**Advisory Action
Before the Filing of an Appeal Brief**

10/538,082

APPLICANT: Gerhard MOGCK ET AL. - 1
SERIAL NO.: 10/538,082 Examiner: E. E. CADUGAN
FILED: October 17, 2005 Group: 3722
TITLE: DEVICE FOR ASSEMBLING, TUNING, AND ...
REPLACEMENT SHEET

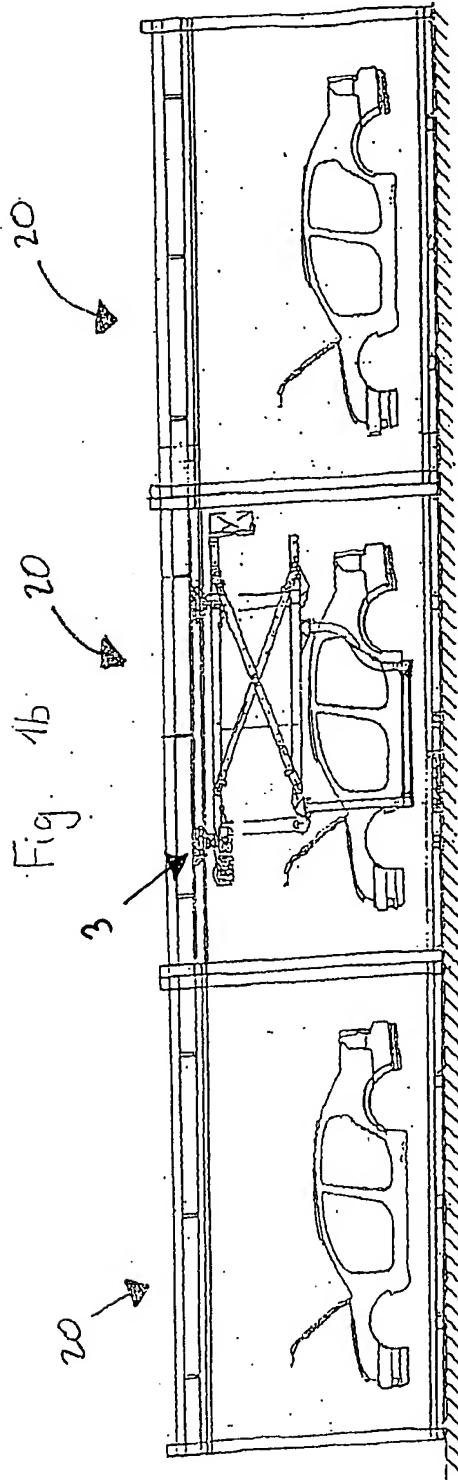
Secondly, it is noted that the proposed reply introduces new matter in at least some of the drawing amendments. For example, in amended Figure 1b, the specification as originally filed does not teach that each of the elements now labeled as 20 are "assembly units", noting that the specification as originally filed also teaches the use of testing and rework units, and thus, for at least this reasoning, it is not inherent that each of the units labeled as 20 in amended Figure 1b are "assembly units" (as also inserted by amendment into the specification on pages 6-7 in the amendment of 12/14/07). Additionally, the amendment to Figure 4 of 12/14/07 includes new matter, noting that the specification as originally filed does not support such a showing of an "assembly hall". For example, it is noted that the specification as originally filed does not teach that the "assembly hall" is located as shown or includes the particular stations shown.

Not
approved
see
1/16/08

As a side note: the proposed Figures 1b and 4 are not approved (in light of the new matter issues mentioned previously) and the proposed Figures 2b, 3b, 3c, 5a-5d are approved.

Fig. 2b

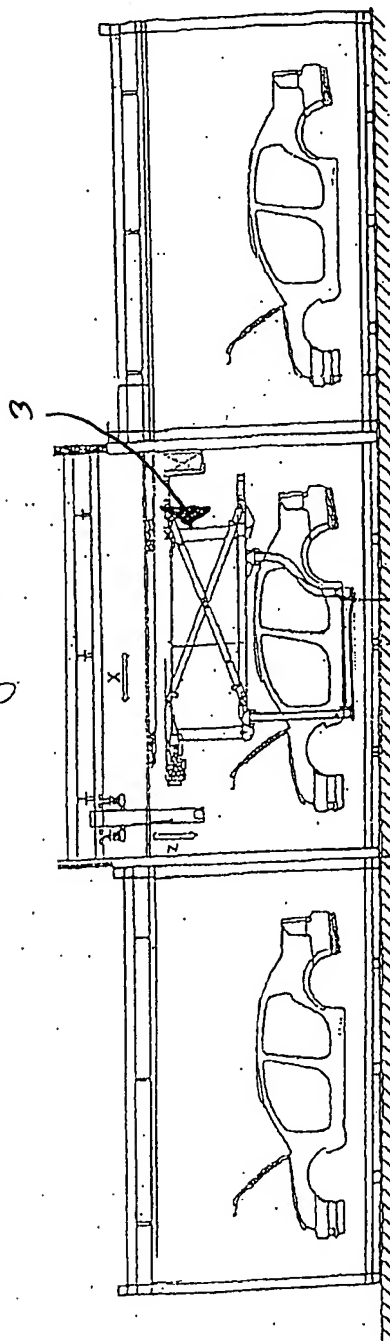
Approved
EAC
1/16/08

Fig. 3b

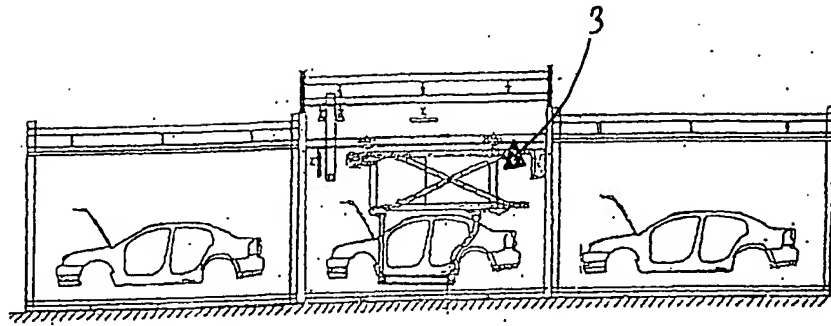
Approved
EdC
1/16/08

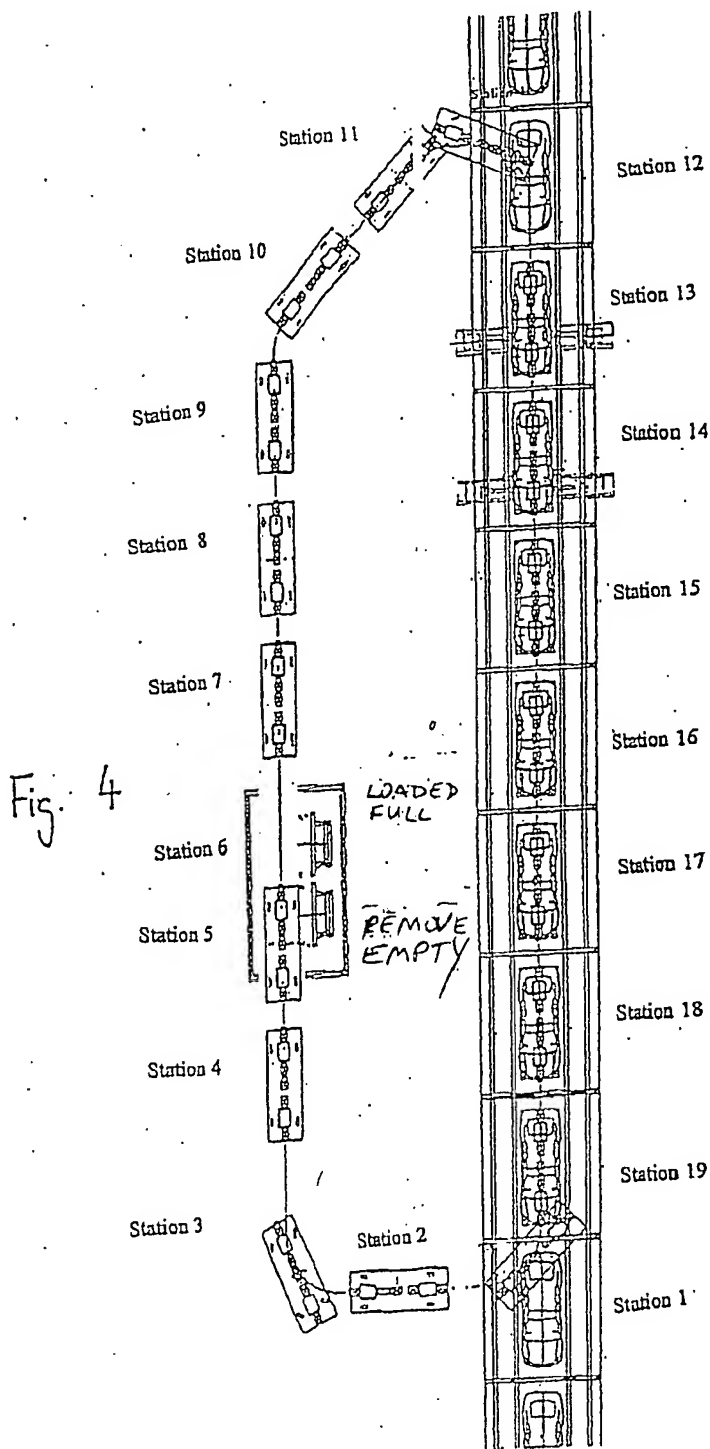
Not
approved
EEC
1/16/08

Fig. 5b

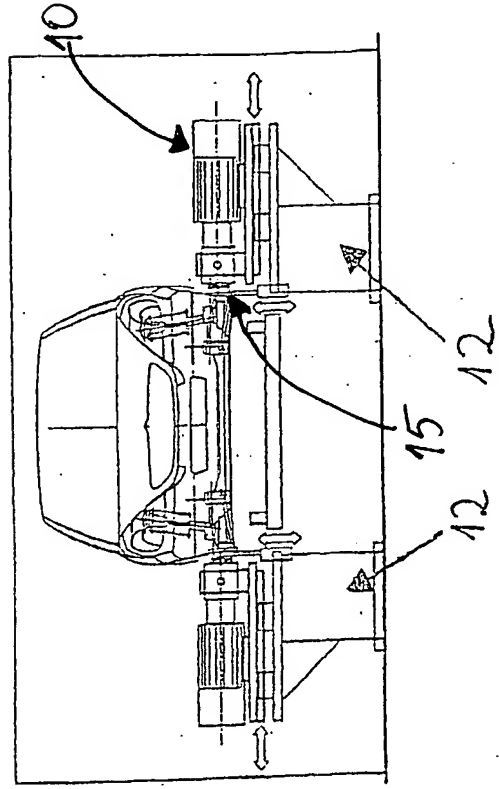
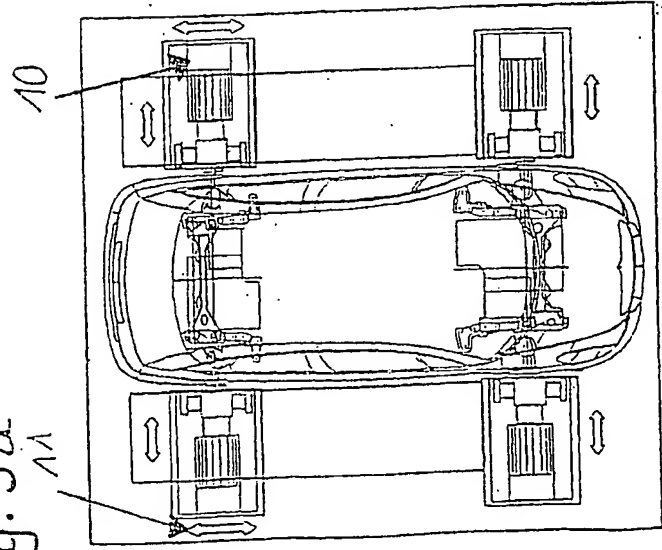
Approved
ECC
1/16/08

Fig. 5d

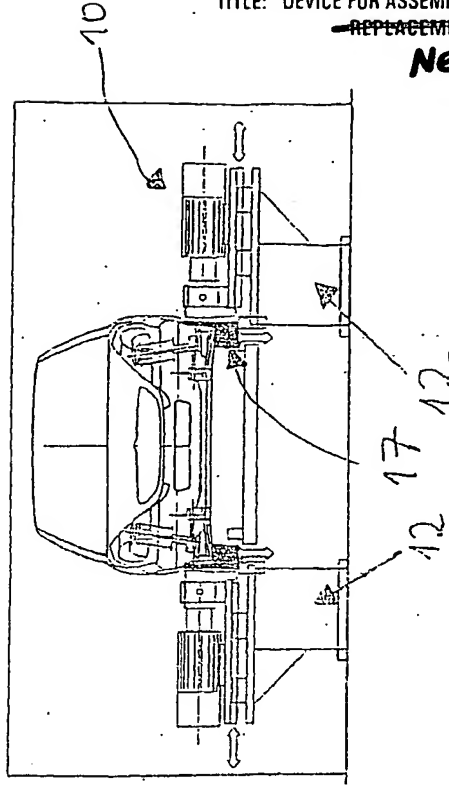
Approved
EEC
1/14/08
